SLOVENSKI STANDARD
SIST HD 384.7.702 S1:2000
01-februar-2000

Electrical installations of buildings - Part 7: Requirements for special installations and locations - Chapter 702: Swimming pools (IEC 60364-7-702:1983, modified)

HD 384.7.702 S1

COMMON MODIFICATIONS

FIG. 702B. — Zone dimensions for basins above ground.

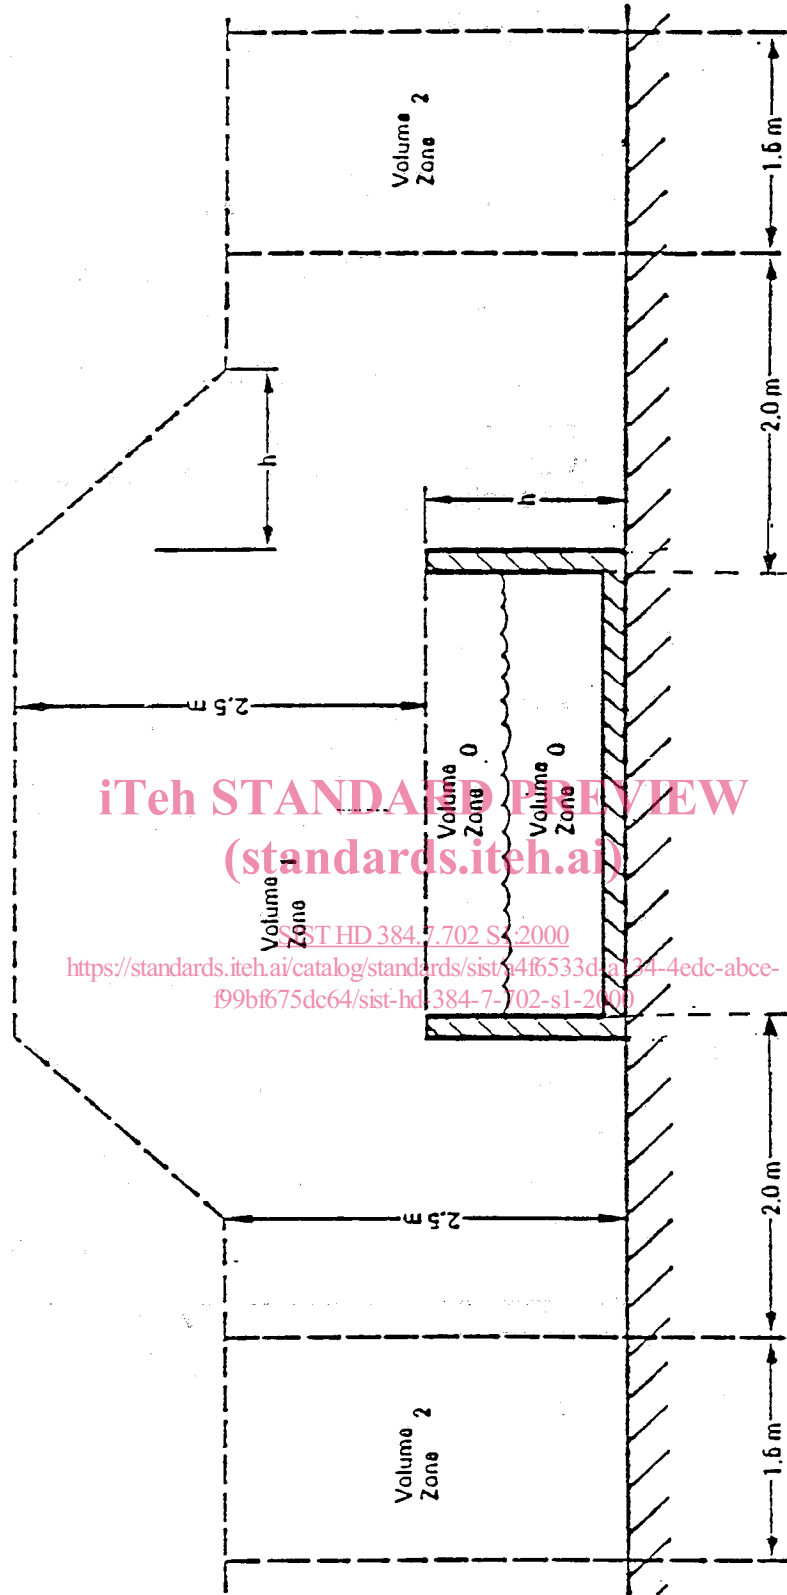
Figure 702B is replaced by the following:

Note. — The dimensions are measured taking account of walls and fixed partitions.
